Planning Commission Staff Report

MEETING DATE: JUNE 1, 2022

SUBJECT: DR21-121, GRAVITY ENERGY

**PRELIMINARY IMPROVEMENT PLAN for
GRAVITY ENERGY DRINKS - VAL VISTA + GERMANN**
18619 SOUTH VAL VISTA DRIVE GILBERT, ARIZONA
grading and drainage plan

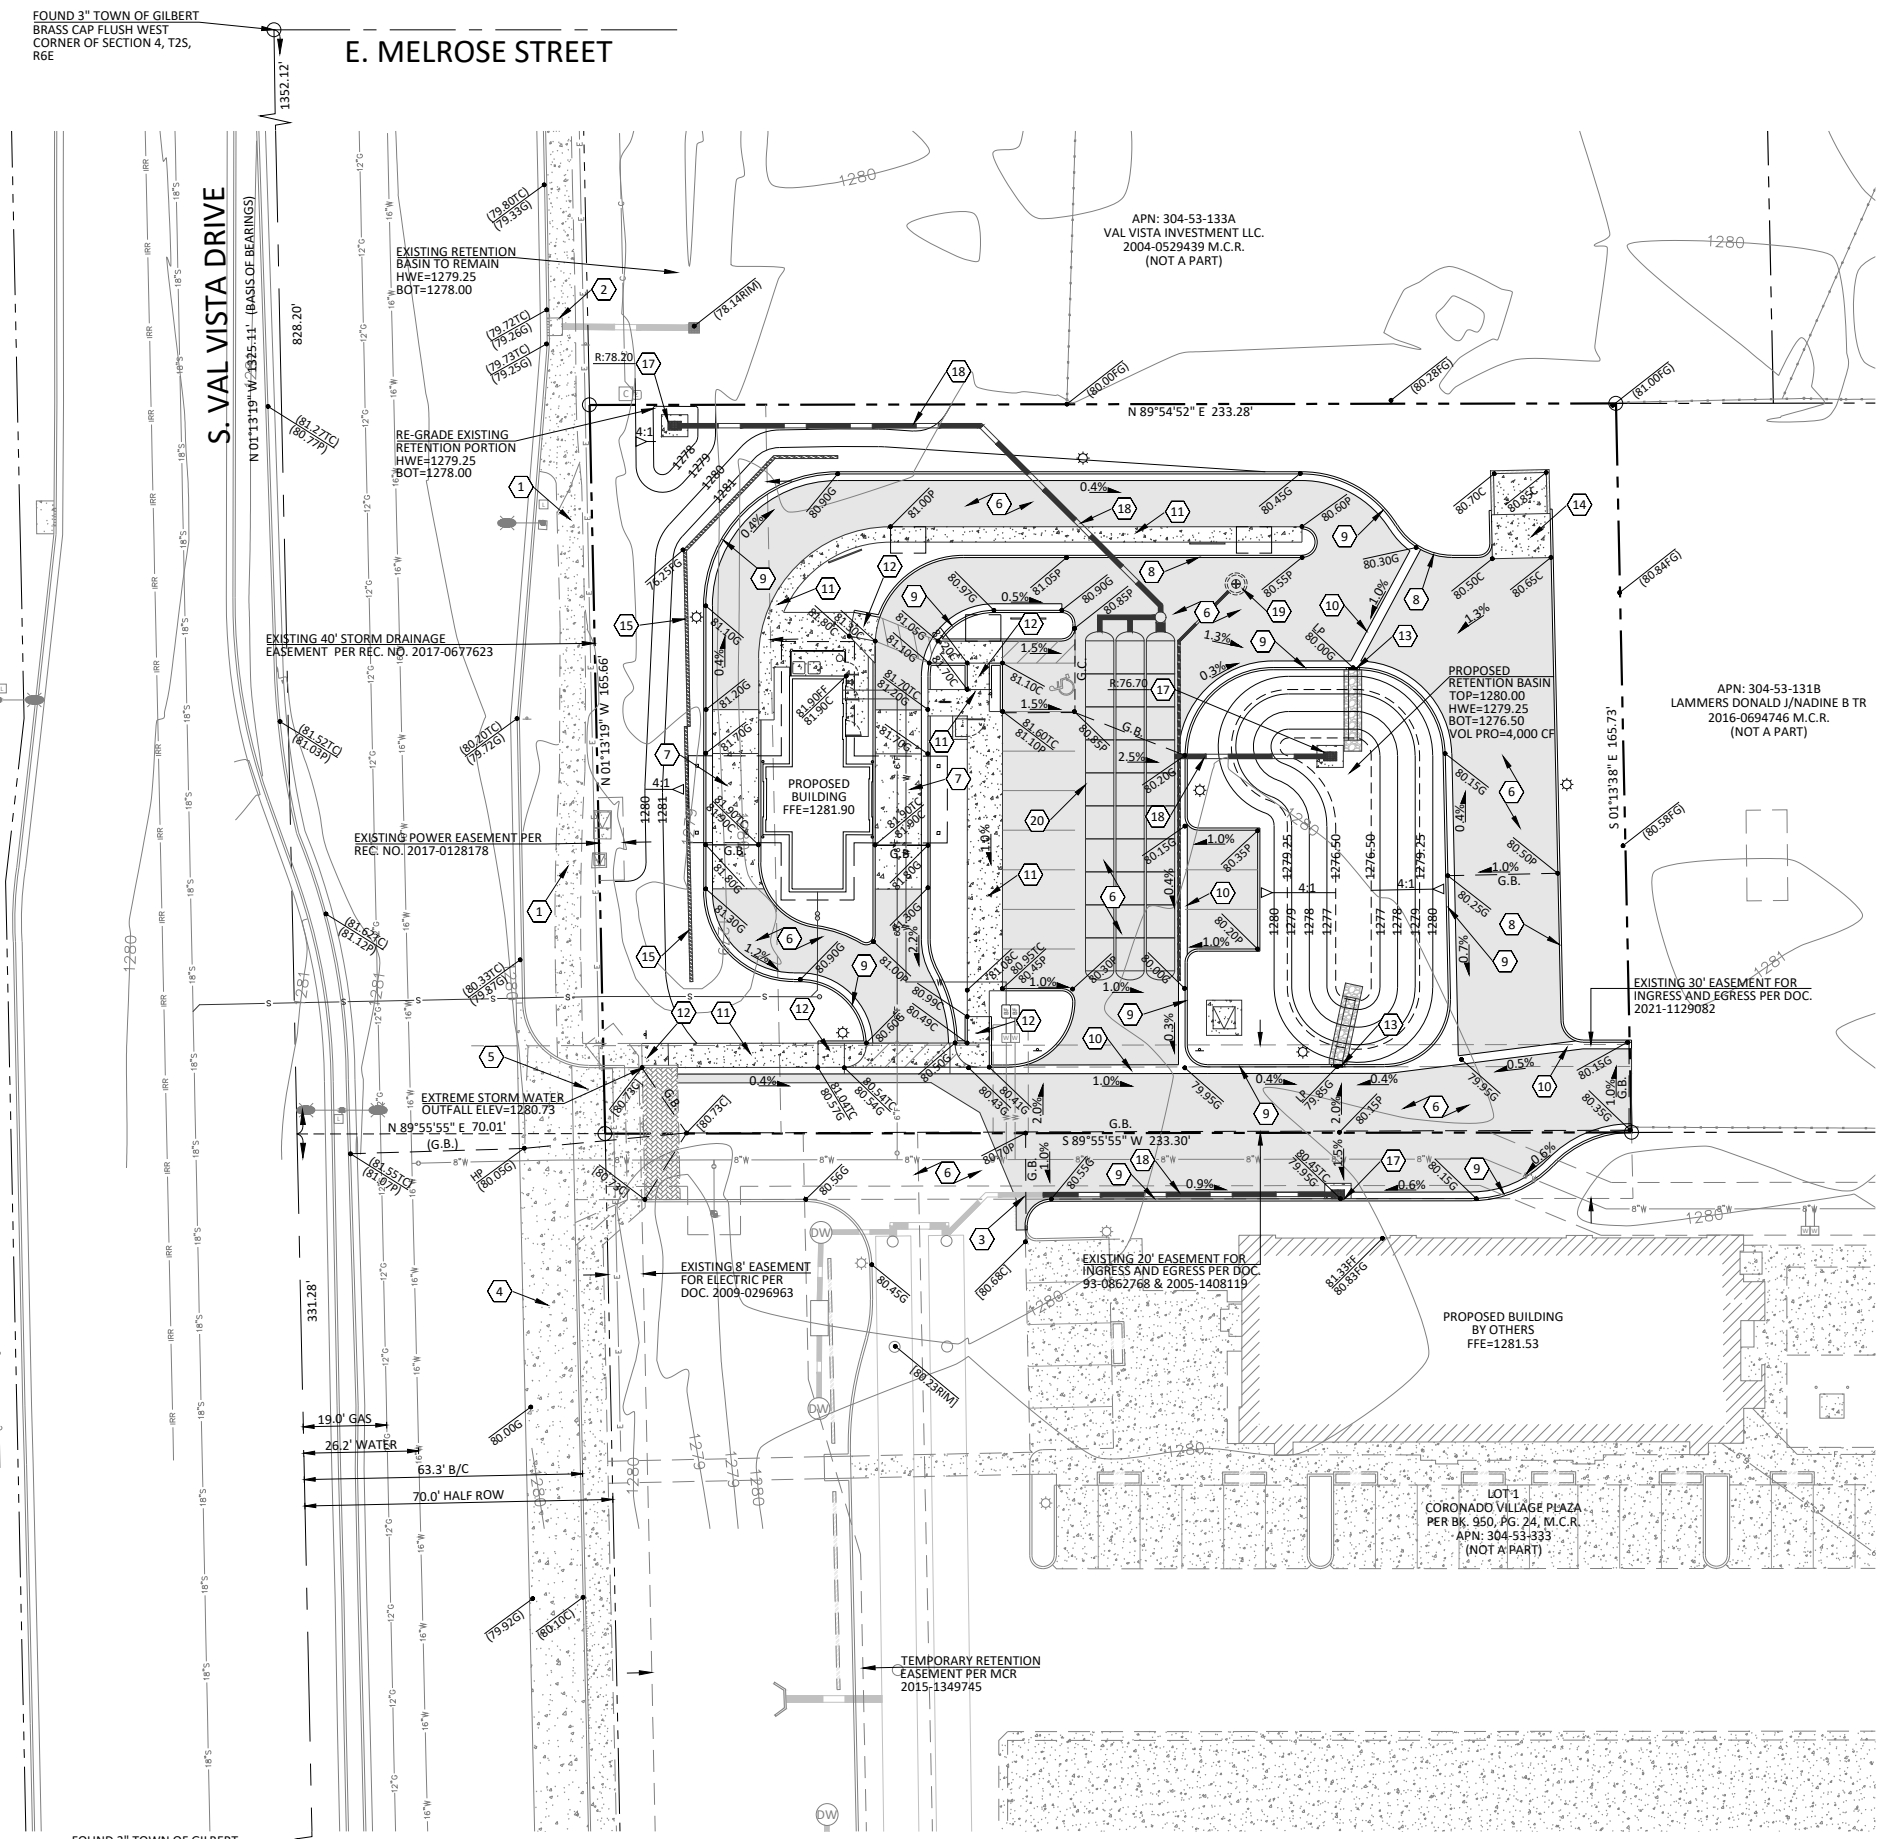
As a condition for approval, drainage and grading plans must be adjusted to demonstrate a 6:1 slope above 3.5' depth within the retention basin, which will cause minor changes to the design of the basin and not affect the overall design of the site. Drawings shall be provided prior to the approval of construction documents and the issuance of building permits.

- c. Drainage and grading plans must be adjusted to demonstrate a 6:1 slope above 3.5' depth within the retention basin, which will cause minor changes to the design of the basin and not affect the overall design of the site. Drawings shall be submitted prior to the approval of construction documents and the issuance of building permits to the applicant.
